Site Control Modification Manual 14H Update

November 2024
Planning Committee

Jonathan Thompson
Interconnection Projects

Exhibit 10: Generator Interconnection into Existing TO Substation

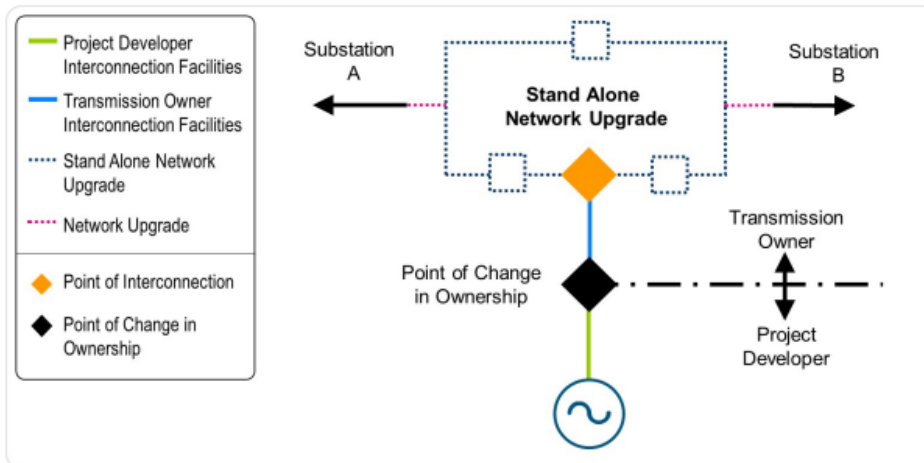
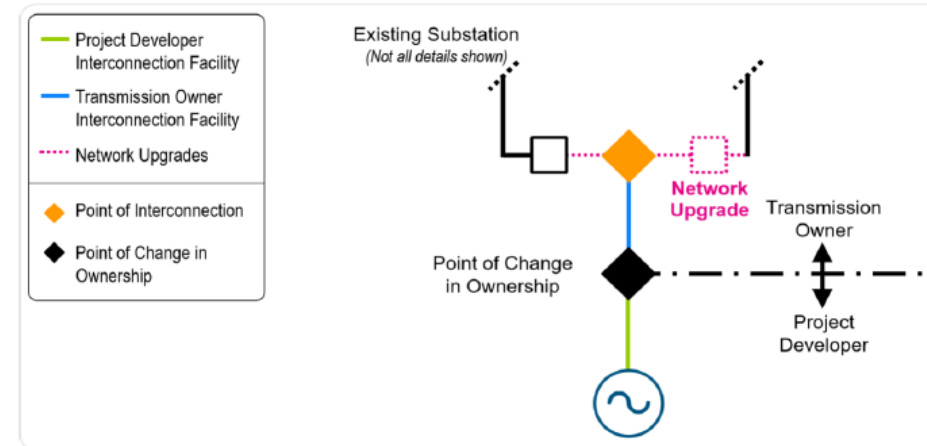
- In M-14H Section 4.9 shows diagrams of typical New Service Request Connection Types
- Exhibit 9 shows “Generator Interconnection via New Interconnection Switchyard”
- Exhibit 10 is supposed to show “Generator Interconnection into Existing TO Substation” but instead is the same diagram used in Exhibit 9

- PJM seeks to correct Exhibit 10
- PJM seeks to provide greater clarification on how Developers can meet tariff requirements for Site Control and what Site modifications are allowed under the tariff
- As PJM continues progress through TC1 and TC2 applications are due in Q4 2024, it is important for Developers to understand what Site Control modifications are allowed under the tariff in order to be able to continue to develop their projects and meet tariff requirements for Site Control at various points of the Interconnection Cycle process
